The X-178 transmission line is a 115 kilovolt (“kV”) line that extends 49 miles from the Beebe River Substation in Campton New Hampshire to the Whitefield Substation in Whitefield, New Hampshire. Upon completion of the replacement work, the X-178 transmission line will remain a 115 kV transmission line, located within the existing right-of-way (“ROW”), between Beebe River Substation and the Whitefield Substation.”

Annotated by kris pastoriza

October 7, 2024, updated December 15th-17th, 2024

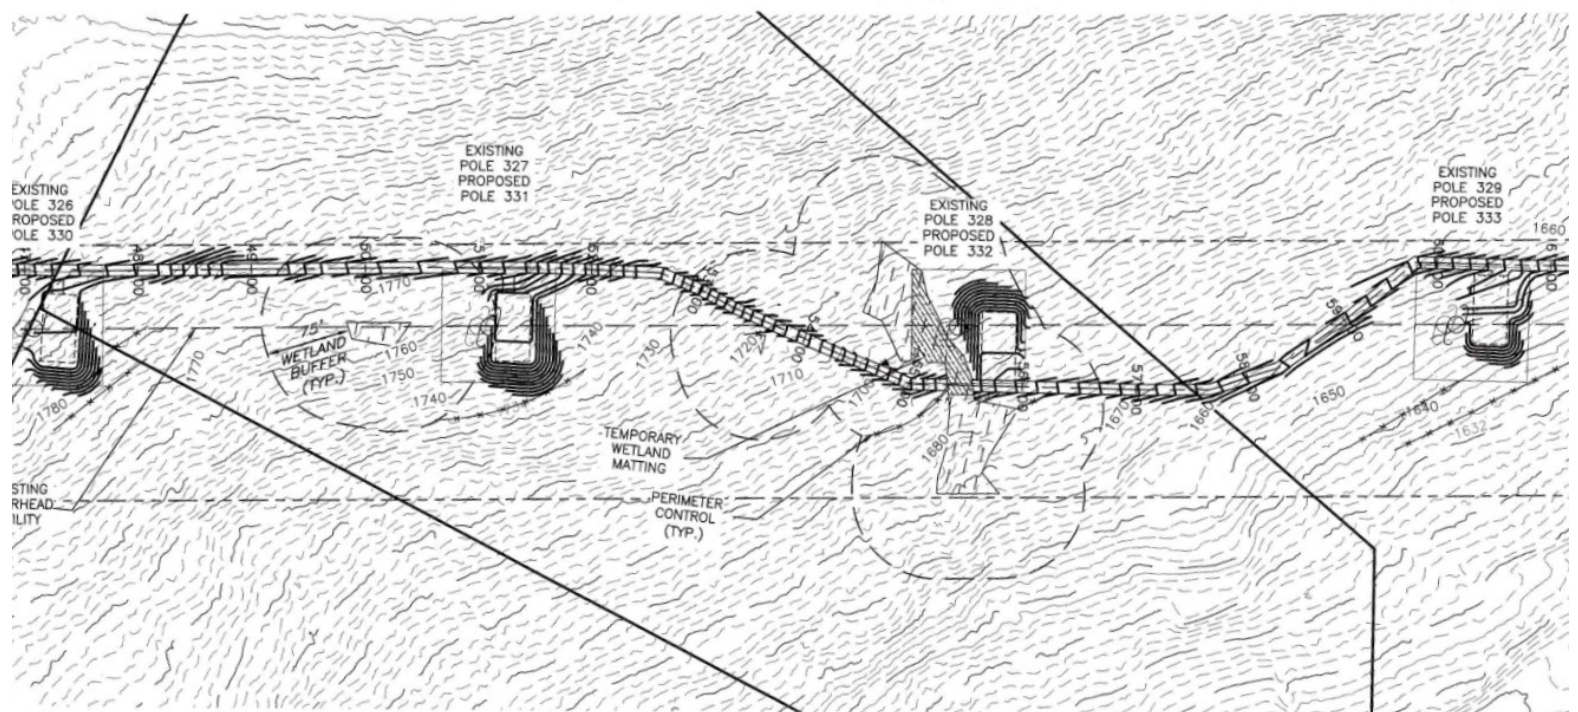
These plans show the easement boundary, 225'. The present cleared area is approx. 120'. Contour lines are 2', crane pads sides are 20-22' high.

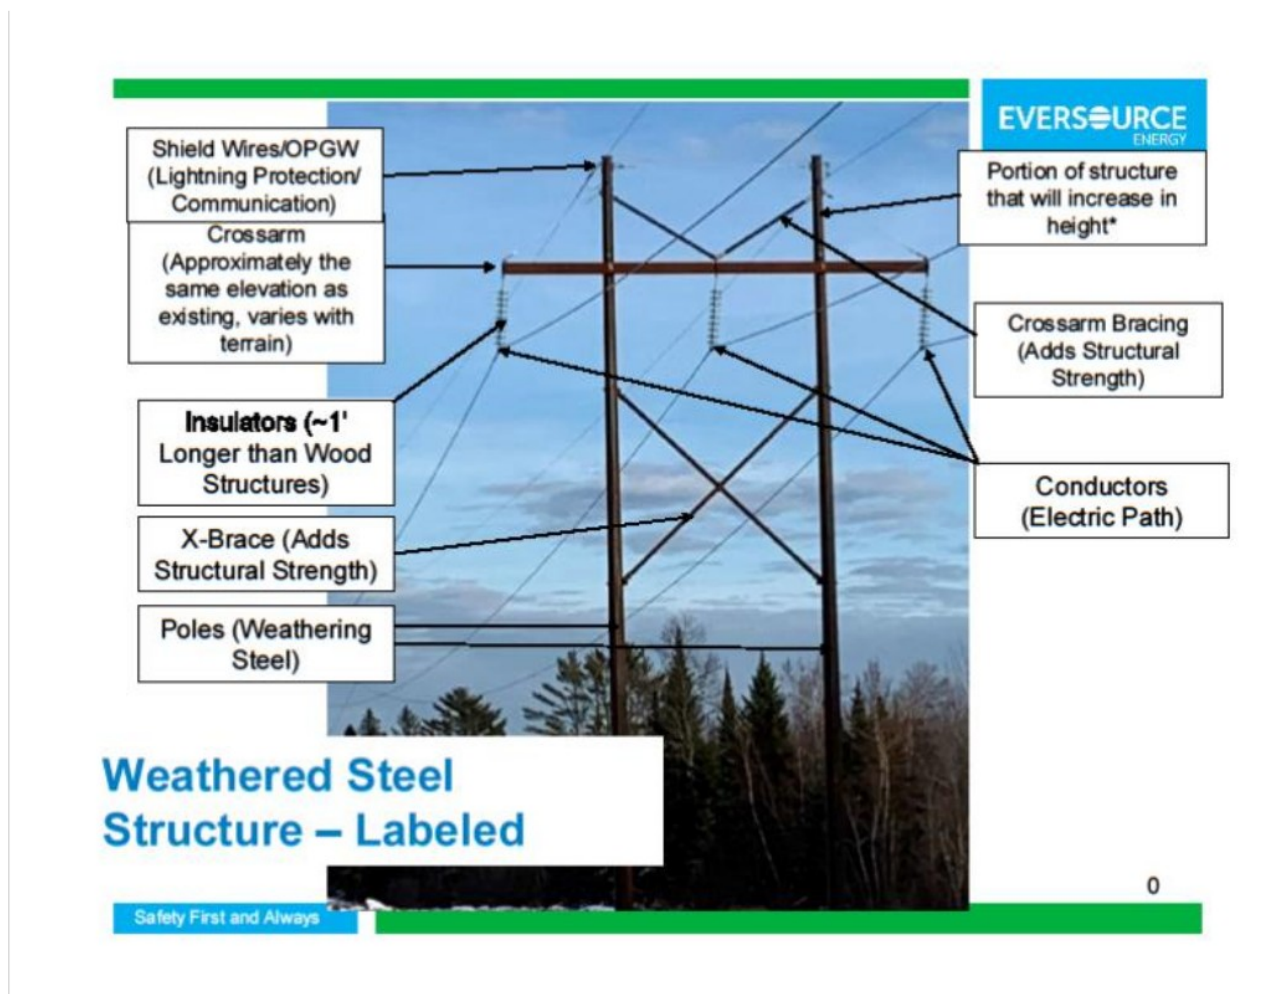
Height increases are driven by the need to comply with current National Electrical Safety Code clearance requirements [for the larger conductor, which has greater sag, and the OPGW, which Eversource claims requires a greater clearance from the conductors than the existing ground wire. Eversource stated that the existing line is not violating Code. Eversource claimed that the height increases would occur between the crossbars and the OPGW, which is contradicted by its proposed structure heights and profile drawings.]

Below, upper right corner: “Portion of structure that will increase in height”

EVERSOURCE NEW HAMPSHIRE TRANSMISSION SYSTEM MAP
10/27/2010 8:25 AM
047943001

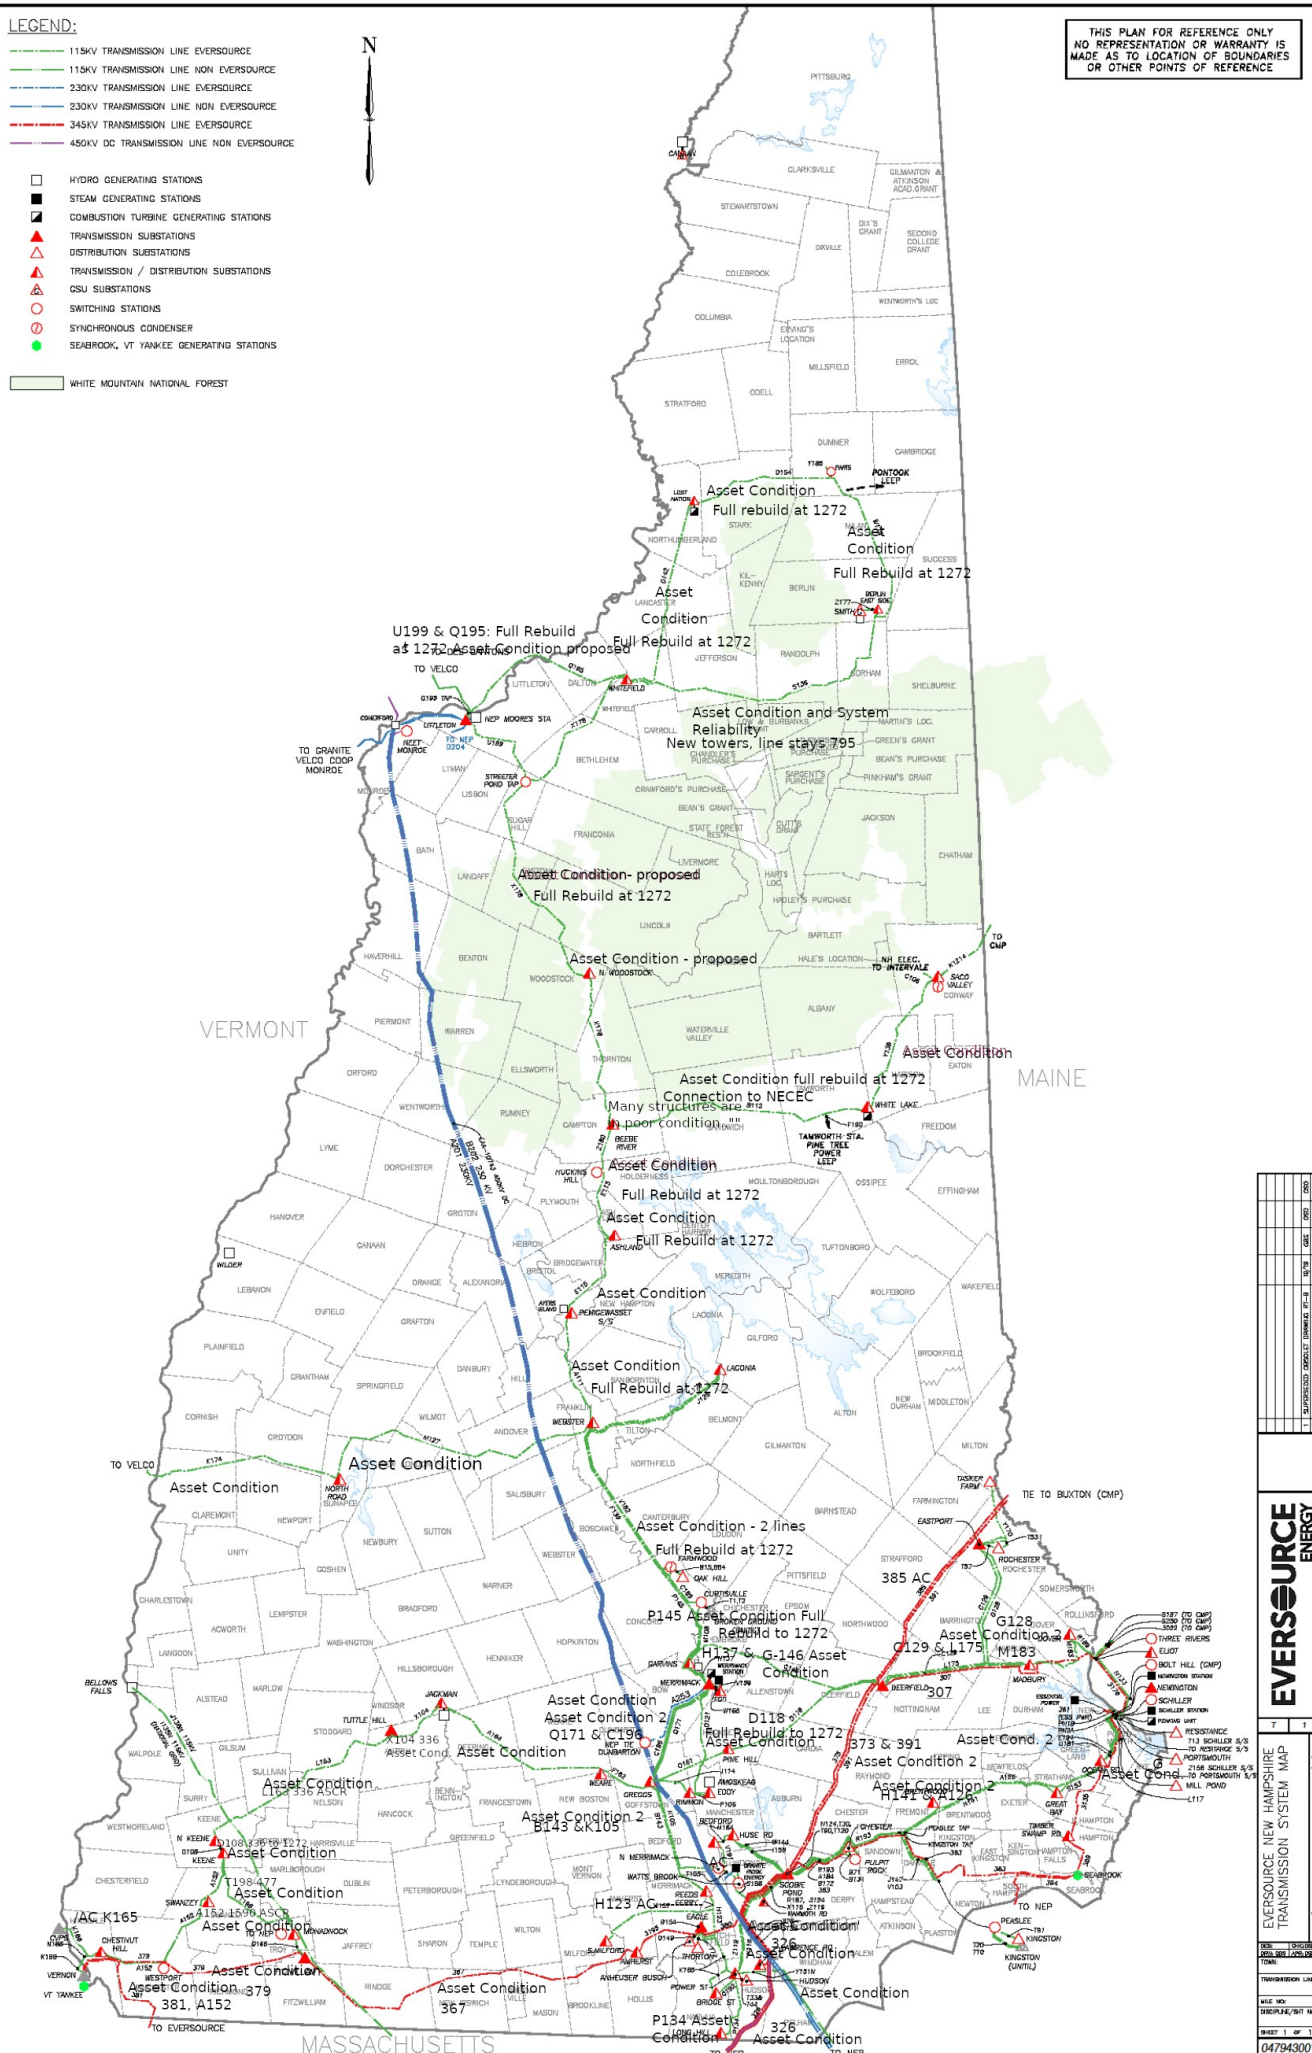
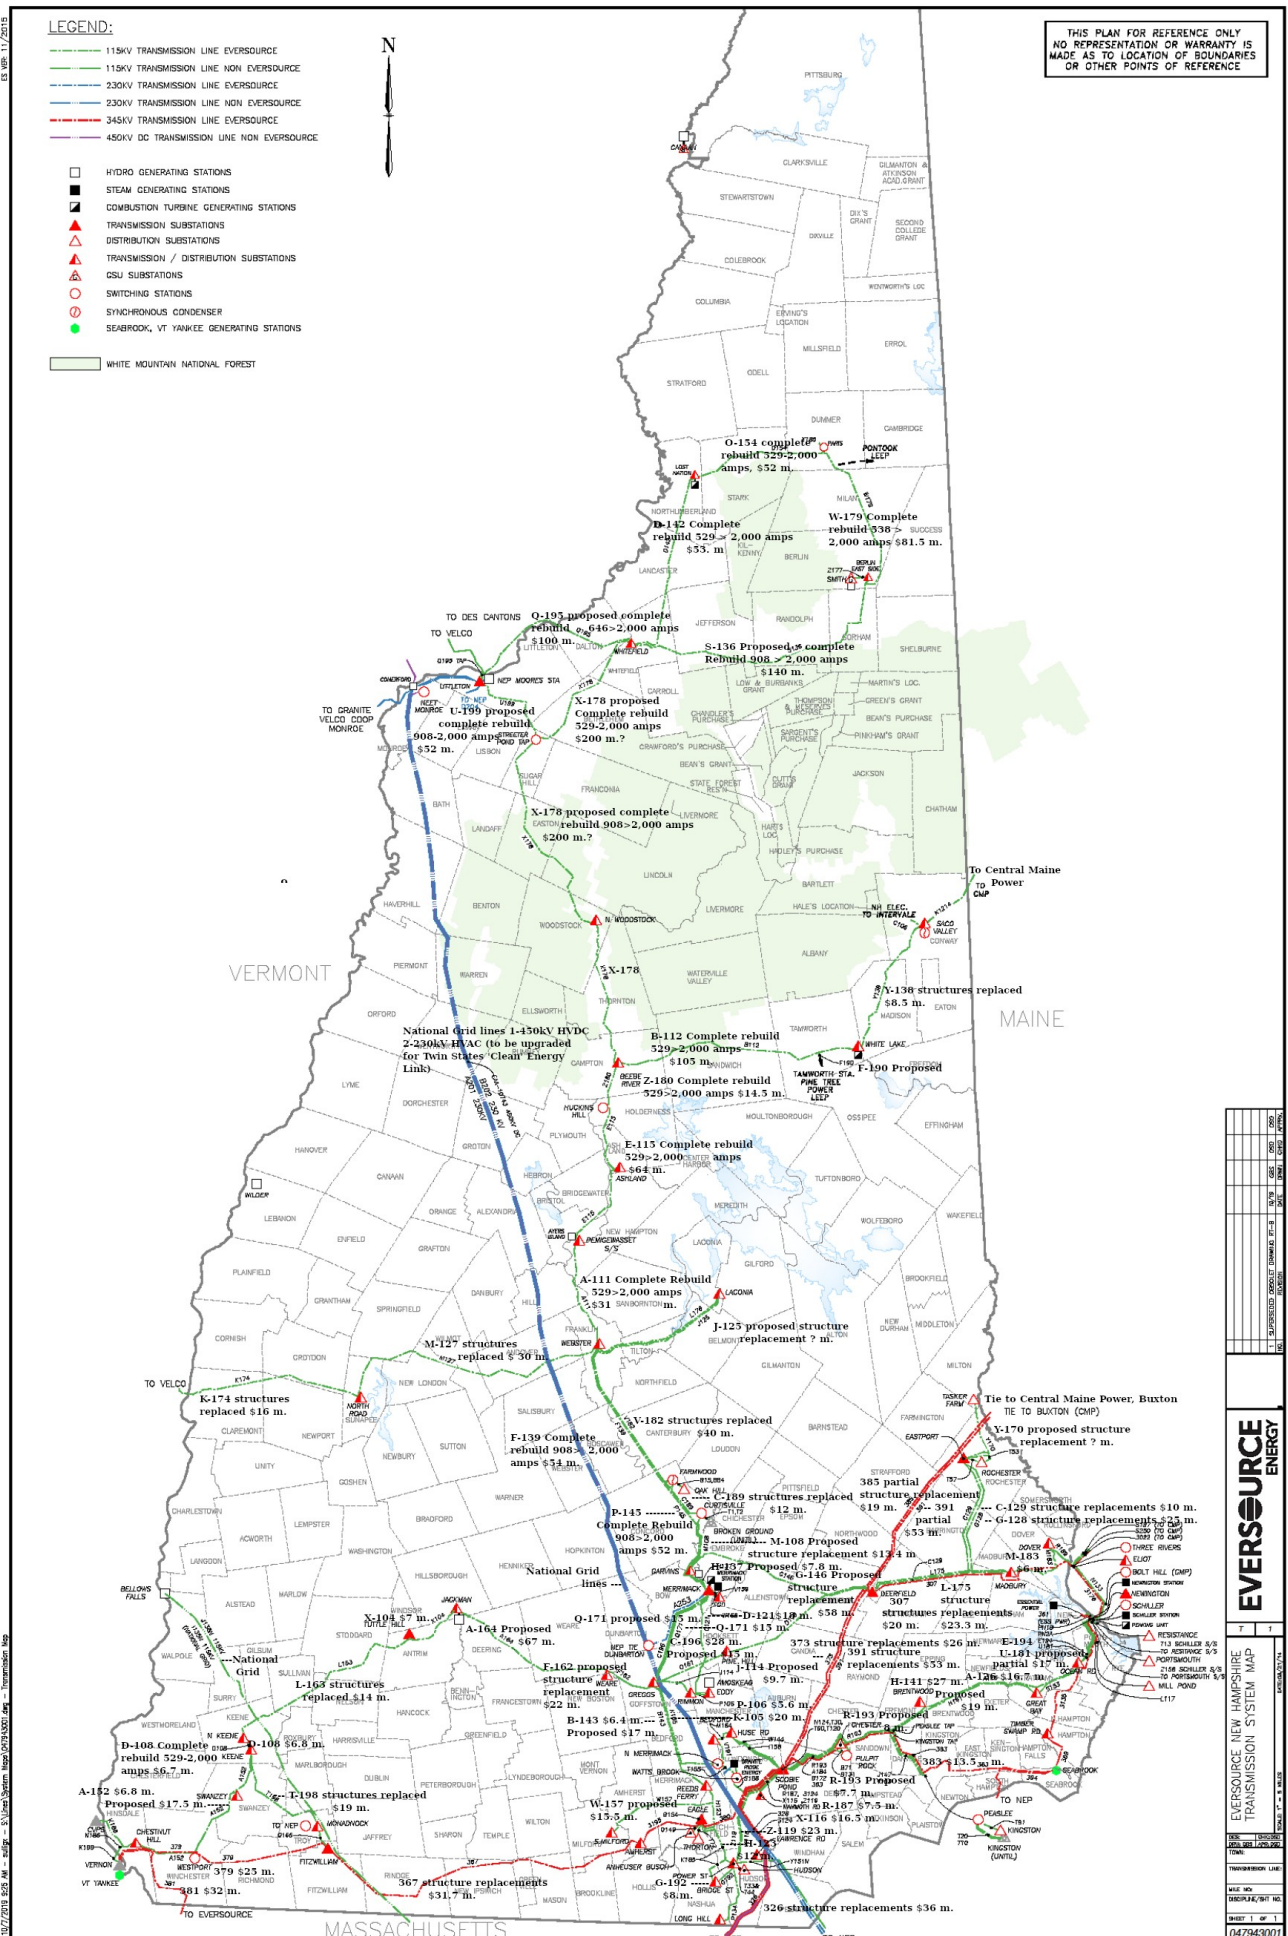
Below, “Asset Condition” projects built or “proposed” by Eversource:

Note: The S-136 Coos Loop line is now under construction as a complete rebuild with Eversource's standard 1272 conductor.

Several new asset condition projects have been added since these maps were made.

Where 2,000 amps is written in the second map the figure should be 2,200.
